ISSUED FOR CONSTRUCTION

ROOF FRAMING PLAN

S1.6

ROOF FRAMING PLAN

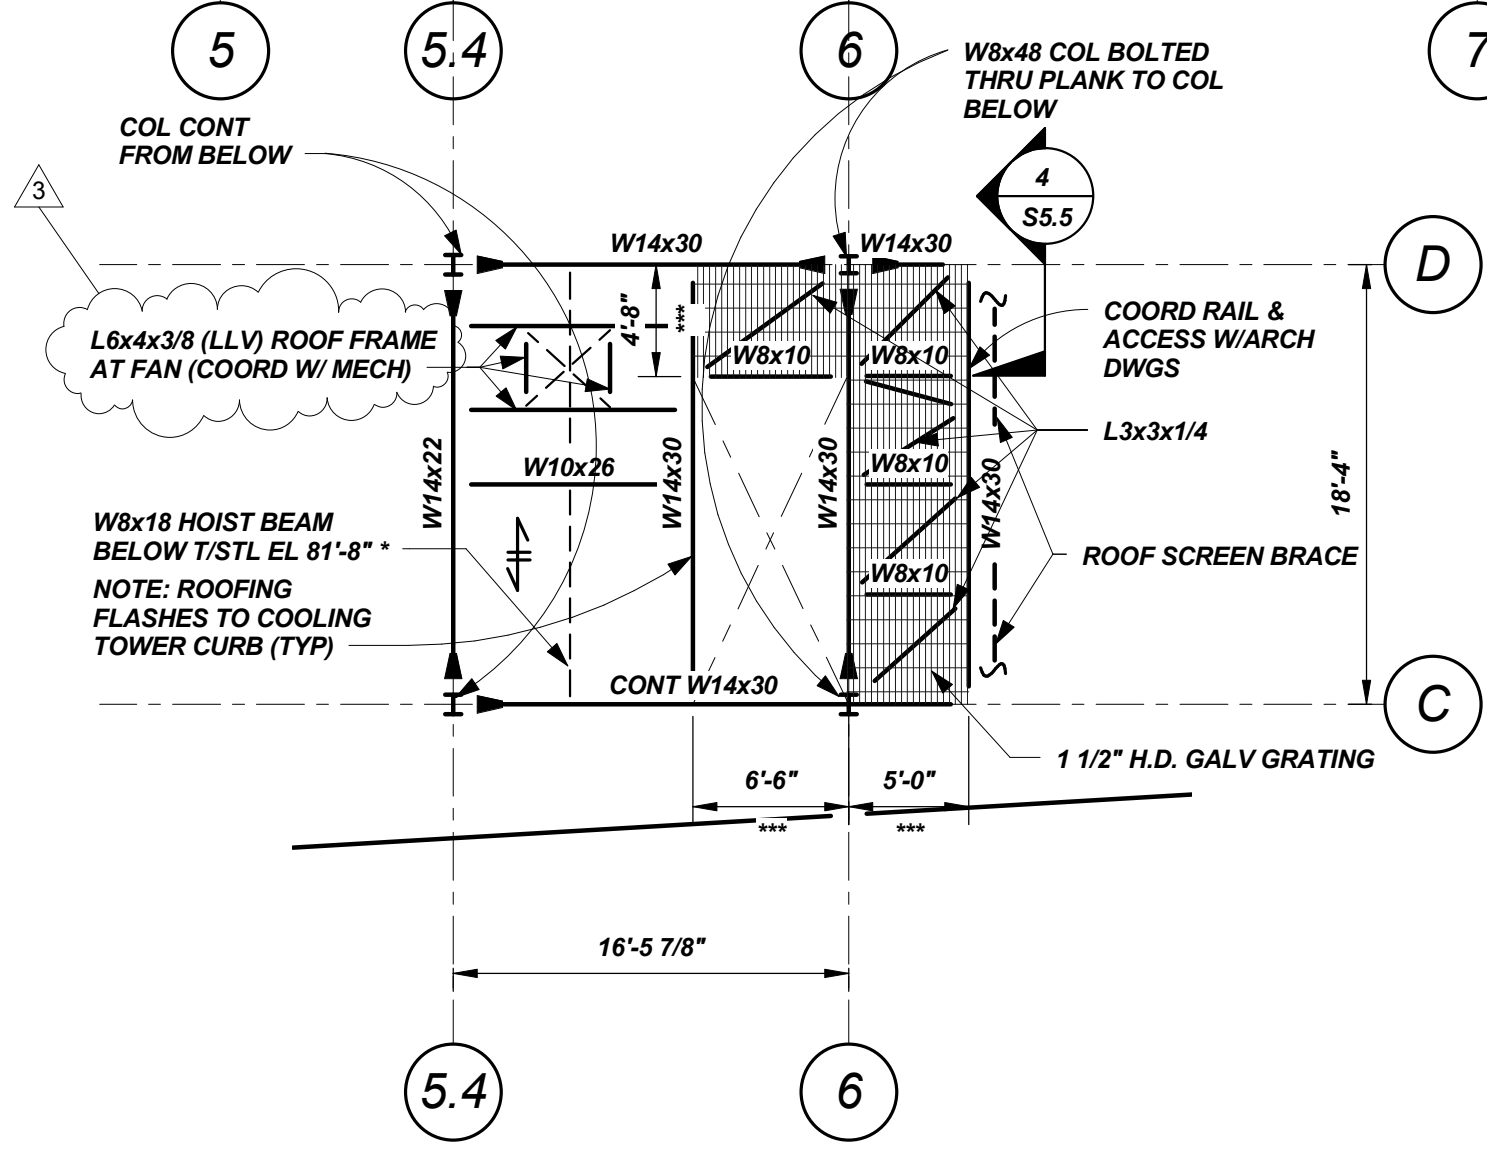
Omit note per RFI 011

RFI 010
